## 00/300 AREA UNIT MANAGER MEETING

100/300 AREA UNIT MANAGERS MEETING  
APPROVAL OF MEETING MINUTES  
January 8, 2009

**Agreement:** Attachment 10 (narrative), Attachment 11 (excel table with proposed sampling changes), and Attachment 12 (maps showing location of sampling points in Attachment 11) are proposed changes to the *Remedial Investigation Work Plan for Hanford Site Releases to the Columbia River*, DOE/RL-2008-11, Rev. 0. RL, EPA, and Ecology approve the proposed changes as outlined in these three attachments.

Figure 2-8

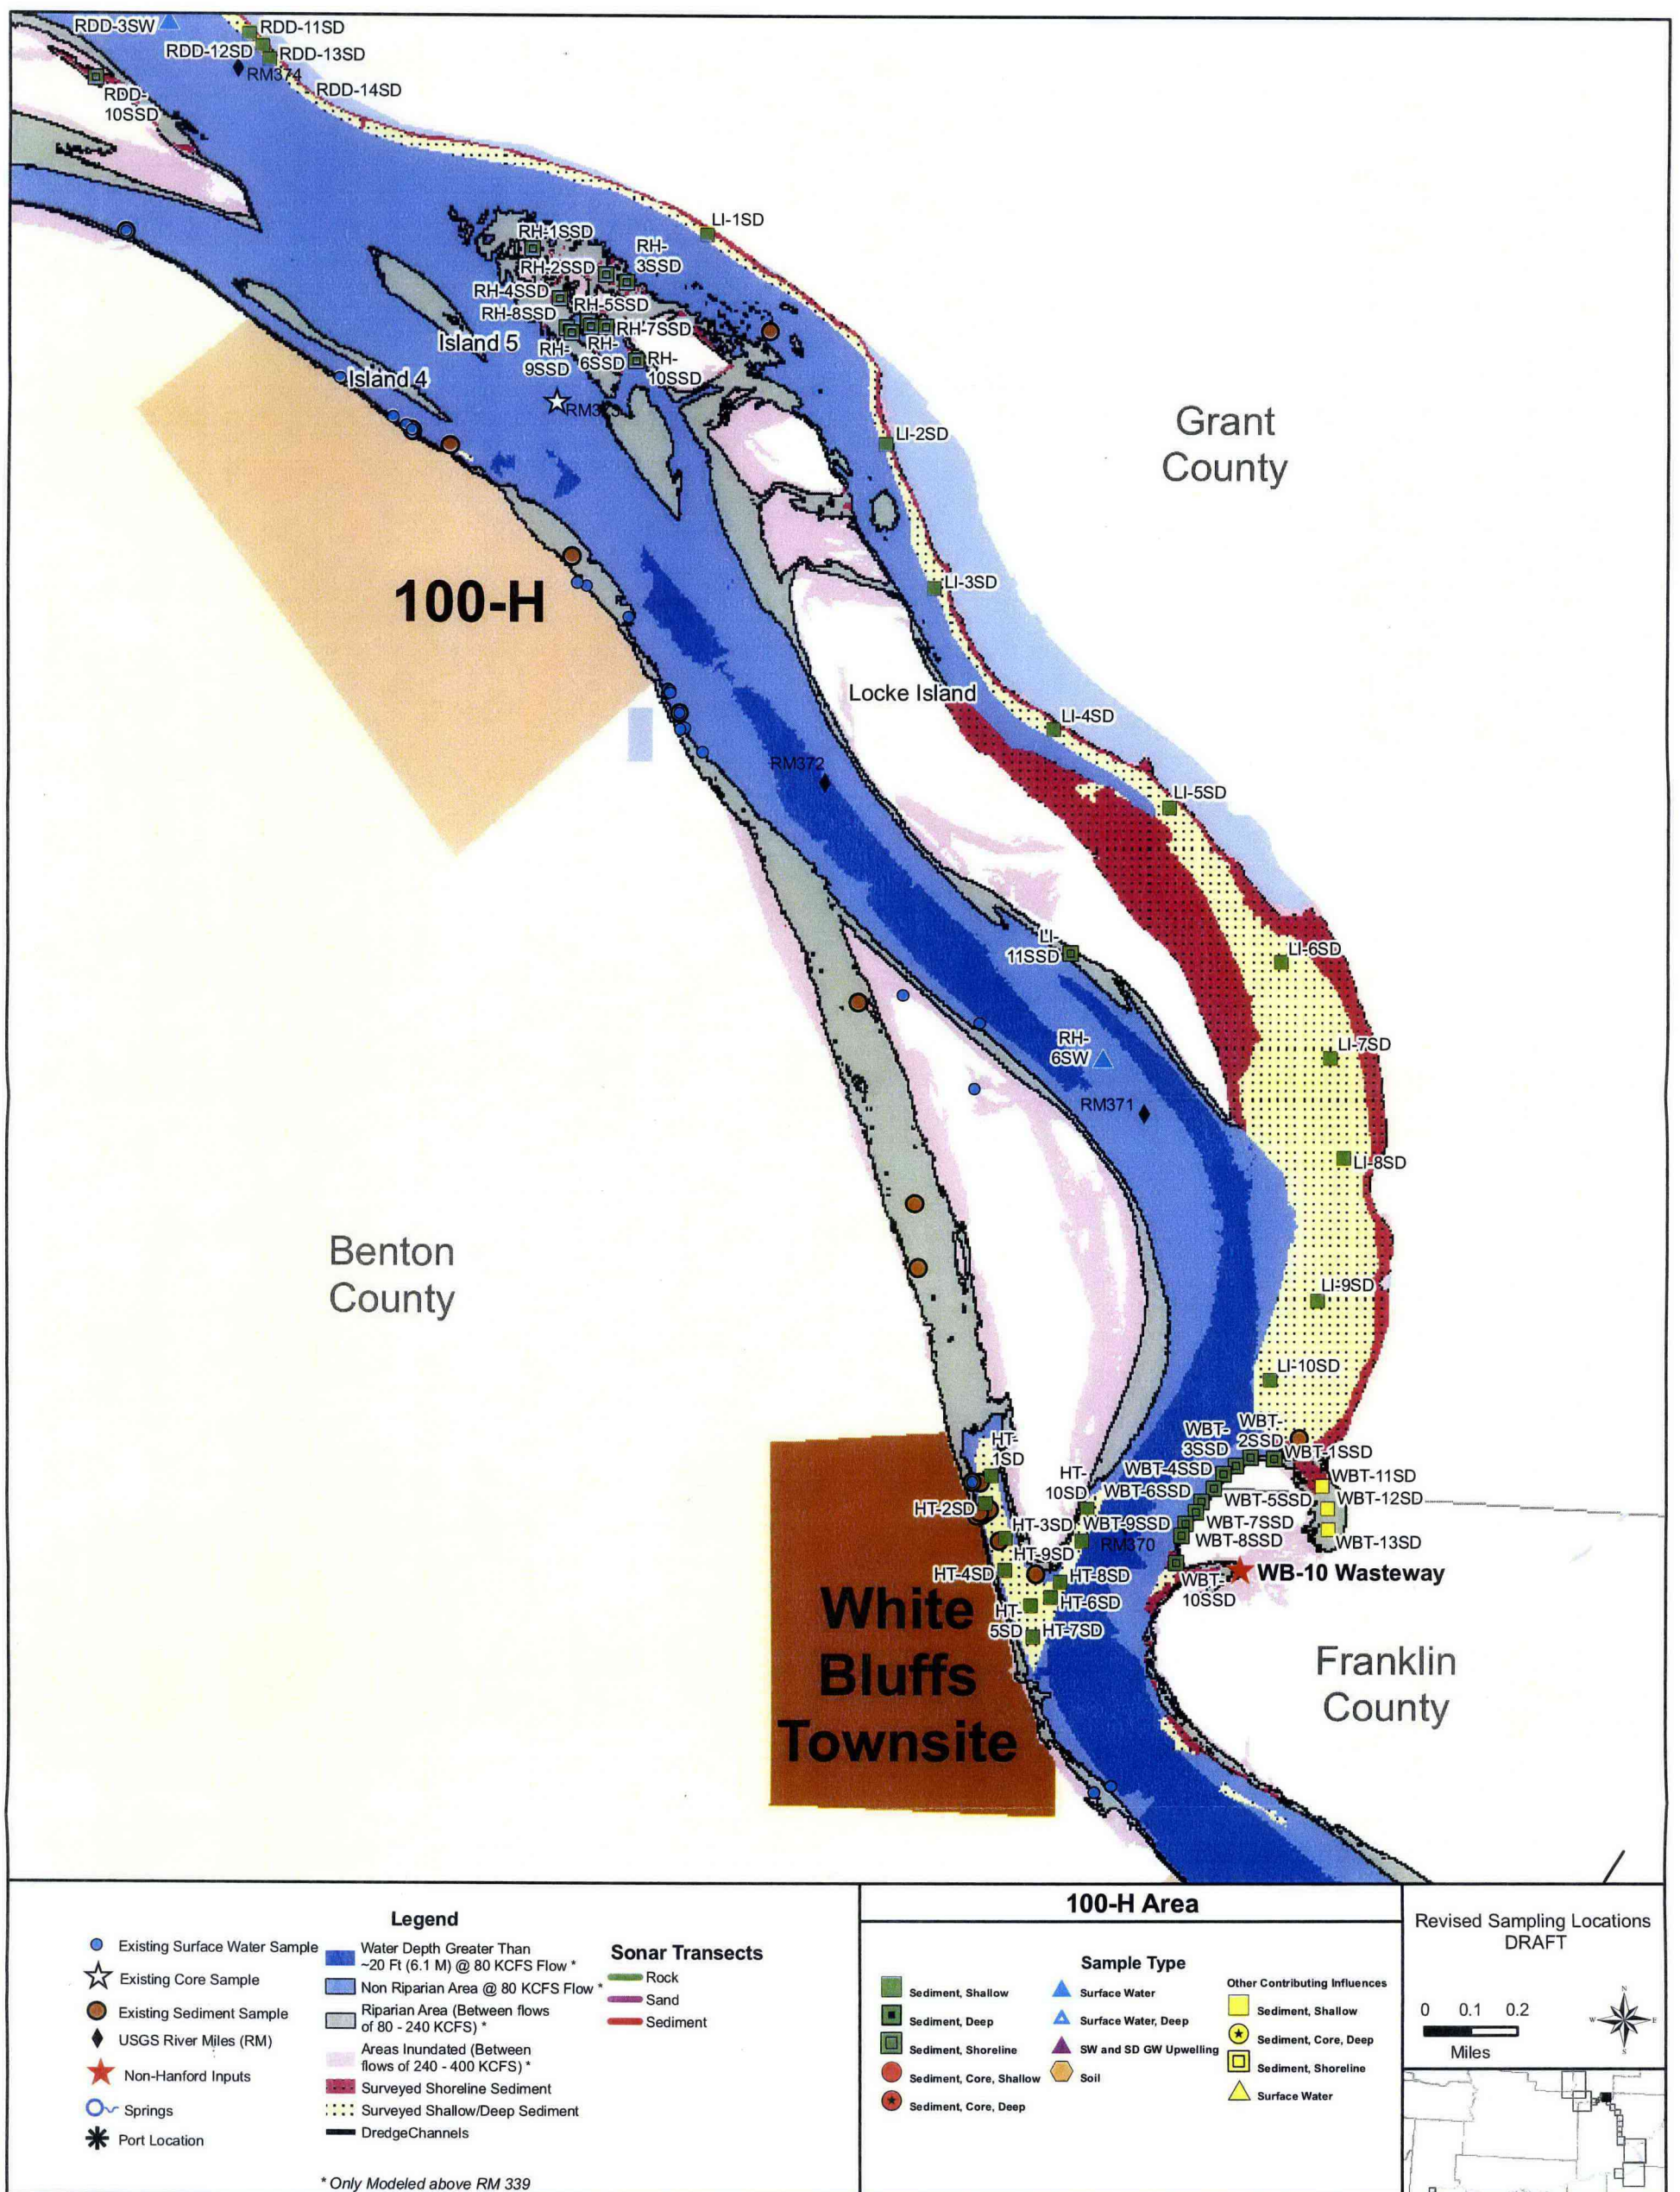
Figure 2-8	Reactor Area	Sediment, Shallow	Ponar	Native American Cultural Site (White Bluffs east side of River)	WBT-1SD to WBT-10SD	Eliminate All	-	All	10	-	-	Random/Stratified	0 - 0.3 ft	Based on sonar survey results, ten samples will be collected from a shallow area on the far (left) shore across from White Bluffs Townsite and at the WB-10 Wasteway.
Figure 2-8	Reactor Area	Sediment, Shoreline	Grab	Native American Cultural Site (White Bluffs east side of River)	WBT-1SSD to WBT-10SSD	All New	-	-	-	Change from shallow sed to shoreline	10	Random/Stratified	0 - 0.3 ft	Due to lack of shallow sediment shoreline sediments added.
Figure 2-8	OCI	Sediment, Shallow	Ponar	WB-10 Wasteway	WBT-11SD to WBT-13SD	Opportunistic	On-Site	-	-	-	-	Focused	0 - 0.3 ft	Three samples will be collected from the shallow sediments downriver of the WB-10 Wasteway to evaluate other contributing influences.
Figure 2-8	Reactor Area	Sediment, Shoreline	Grab	Reactor H Island Shoreline Sediment	RH-1SSD to RH-10SSD	No sed on Island 5, move to upriver end of Locke Is	All	-	-	-	-	Random/Stratified	0 - 1 ft	Based on an ecological habitat survey, ten samples will be collected. Five samples will be collected from the shallow area upriver and adjacent to Island 5; another five samples will be collected from the shallow area on the downriver portion of Island 5.

Figure 2-8	White Bluffs Townsite	Sediment, Shallow	Ponar	Bottom of H-Slough Shallow Sediment	HT-1SD to HT-10SD	All New	-	-	-	New Samples	10	Random/Stratified	0 - 0.3 ft	New area of shallow sediment not previously identified.

Figure 2-9

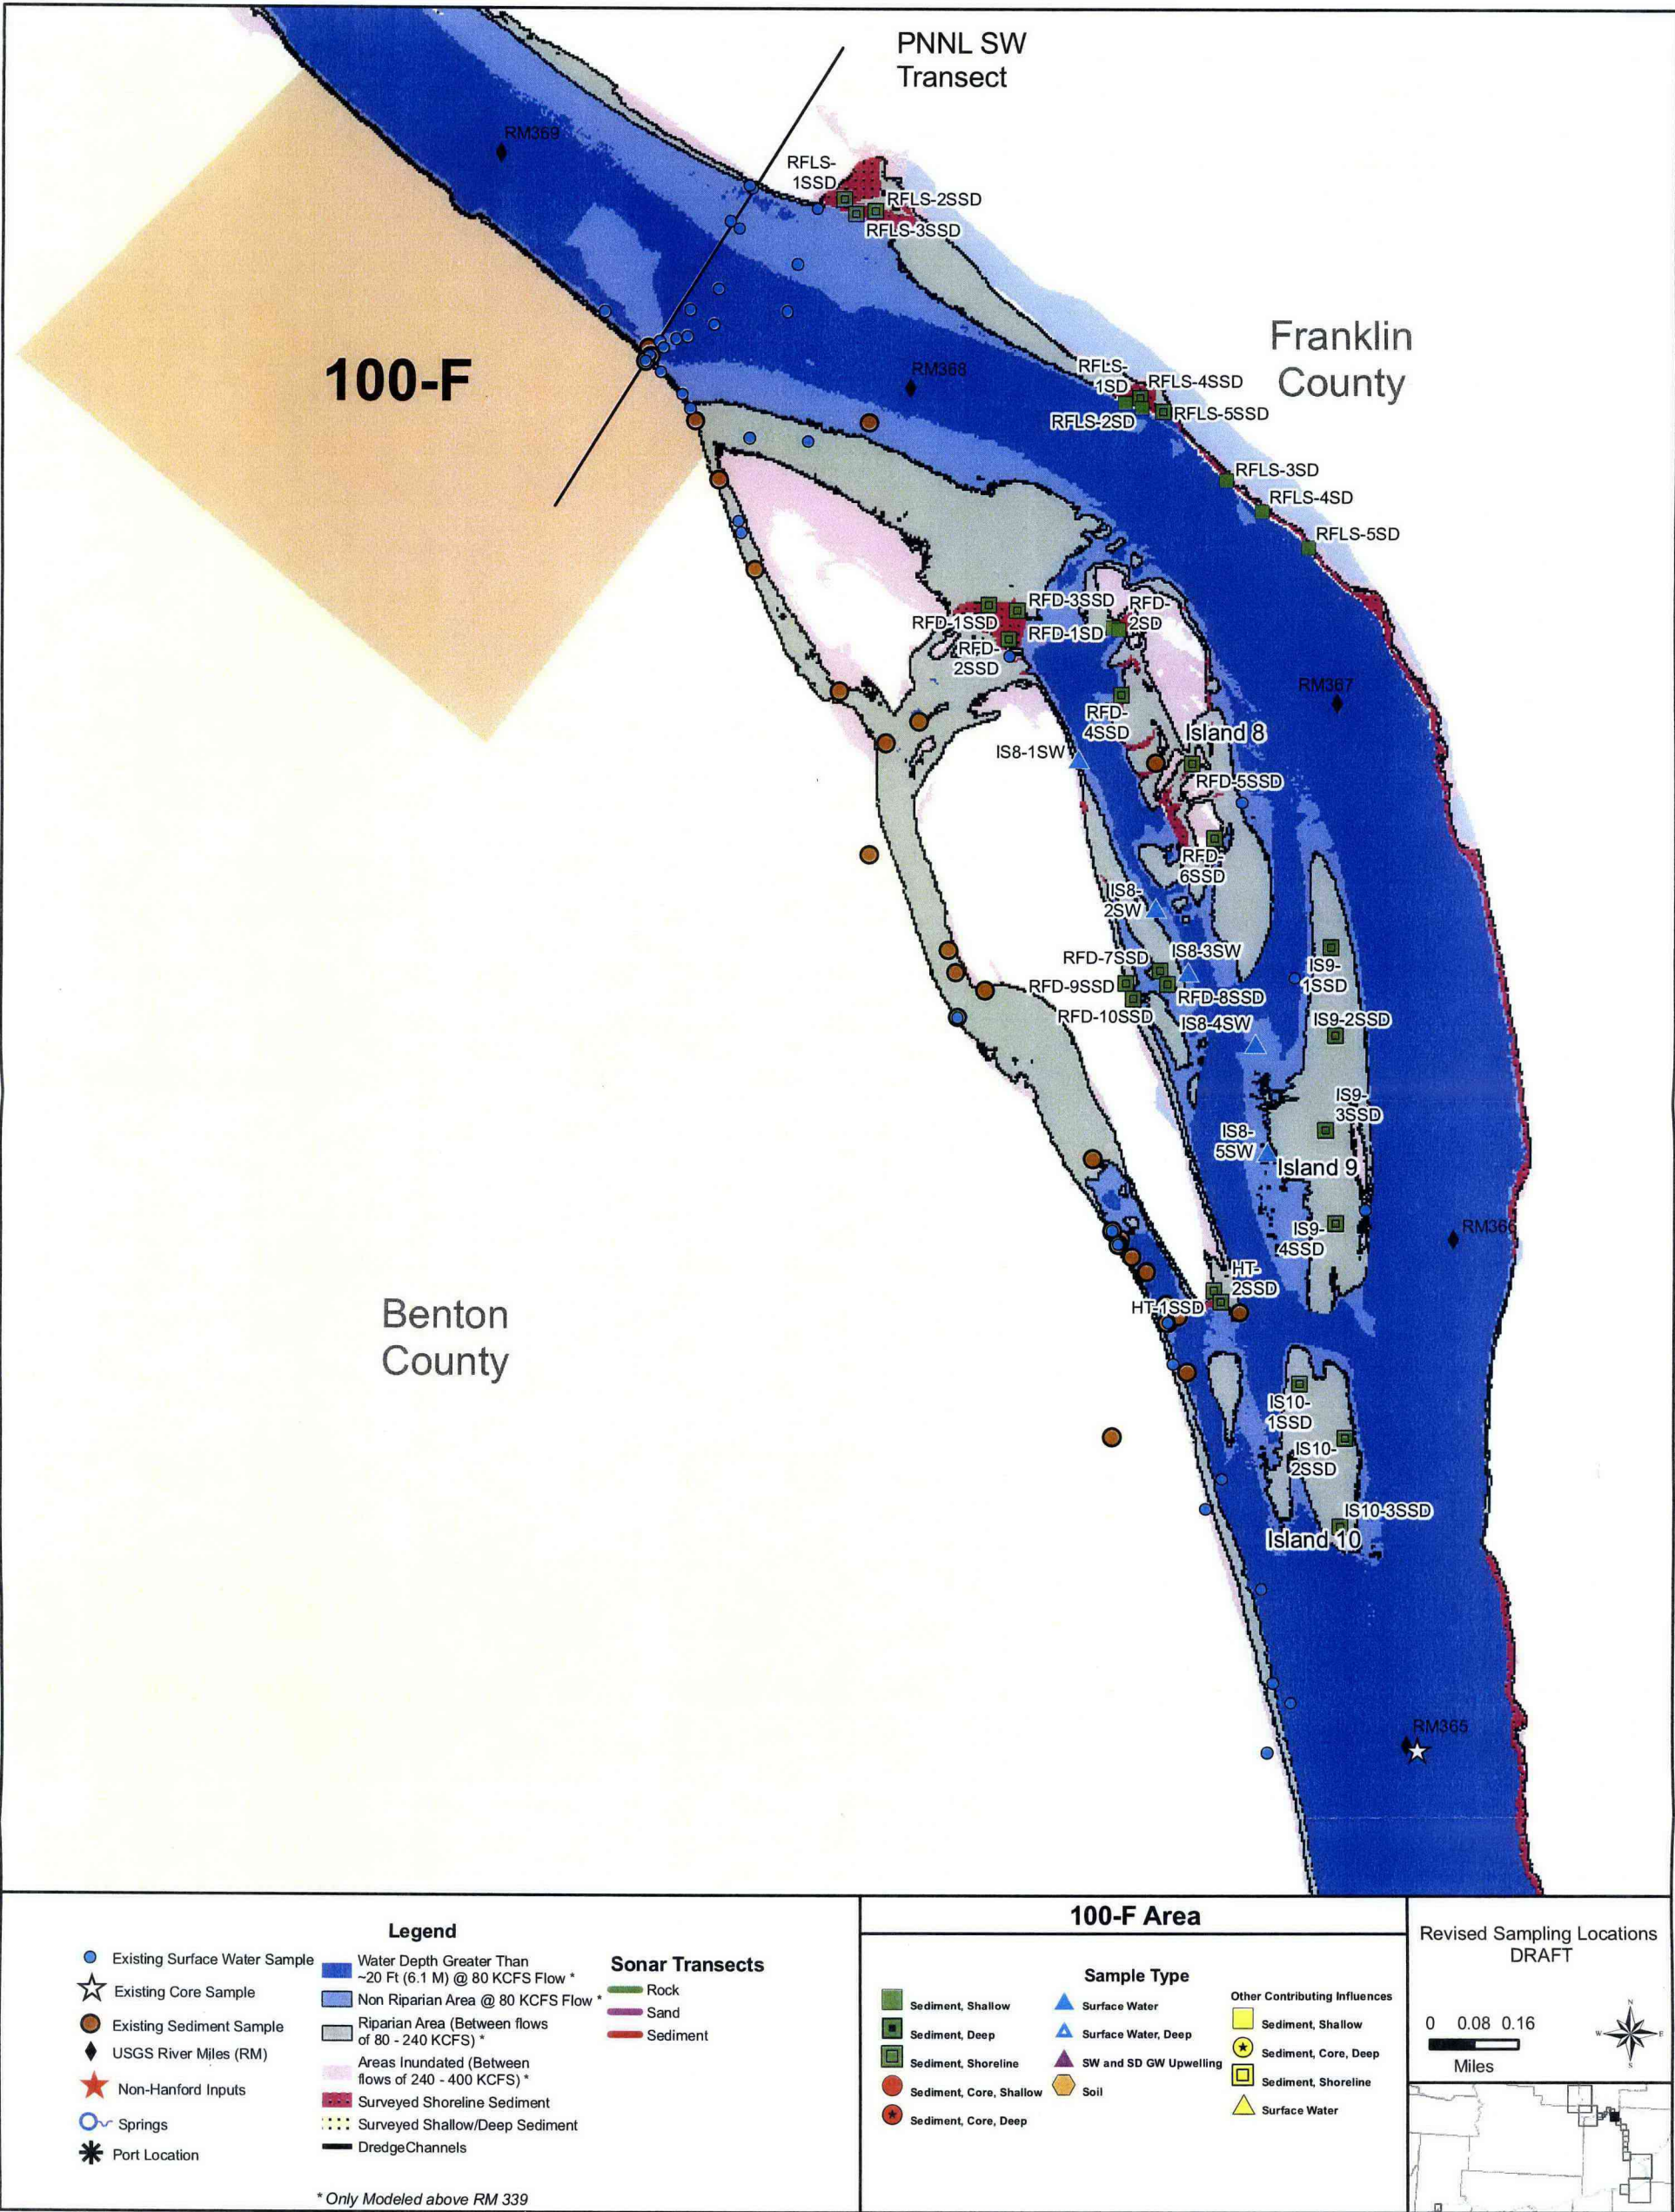
Figure 2-9	Reactor Area	Sediment, Shallow	Ponar	White Bluffs downriver Sediments	WBD-1SD to WBD-10SD	Eliminated due to lack of sediment	-	Eliminated	10	-	-	Random/Stratified	0 - 0.3 ft	Based on sonar survey results, ten samples will be collected from the shallow area adjacent to Area 100-F.
Figure 2-9	Reactor Area	Soil	Grab	White Bluffs island soil	WB-1S to WB-10S	Limited	All	-	-	-	-	Random/Stratified	0 - 0.5 ft	Ten surface soil samples will be randomly taken from the island across from White Bluffs townsite using a 10 cell grid to minimize cultural impacts. The samples will supplement previous sampling events and provide additional data for ecological and human evaluations.
Figure 2-9	Reactor Area	Sediment, Shallow	Ponar	Reactor F downriver Sediments	RFD-1SD to RFD-2SD	Limited	-	RFD-3SD to 10SD	8	-	-	Random/Stratified	0 - 0.3 ft	Based on sonar survey results, samples will be collected from the shallow area between the upriver end of Island 8 and the near (right) shore.

Sample Description														Rationale
Figure	Designation	Sample Type	Collection Method	Sampling Location	Temporary Sample ID	Adjustments	Confirmed Location	Eliminated		Add		Sample Design	Sample Depth	
								Notes	#	Notes	#			
Figure 2-9	Reactor Area	Sediment, Shoreline	Grab	Reactor F downriver Shoreline Sediments	RFD-1SSD to RFD-10SSD	Limited	All	-	-	-	-	Random/Stratified	0 - 0.3 ft	Based on an ecological habitat survey, ten samples will be collected from riparian areas; three just upriver of Island 8; one sample between the upriver portion of Island 8 and the near (right ) shore; two downriver and adjacent to Island 8; two upriver of Island 9 and two adjacent to Island 9 on its near (right) shore side.
Figure 2-9	Island 9	Sediment, Shoreline	Grab	Island 9	IS9-1SSD to IS9-4SSD	New Samples	All	-	-	IS9-1SSD to 4SSD	4	Random/Stratified	0 - 0.3 ft	New samples located on Island #9
Figure 2-9	Island 10	Sediment, Shoreline	Grab	Island 10	IS10-1SSD to 3SSD	New Samples	All	-	-	IS10-1SSD to 3SSD	3	Random/Stratified	0 - 0.3 ft	New samples located on Island #10
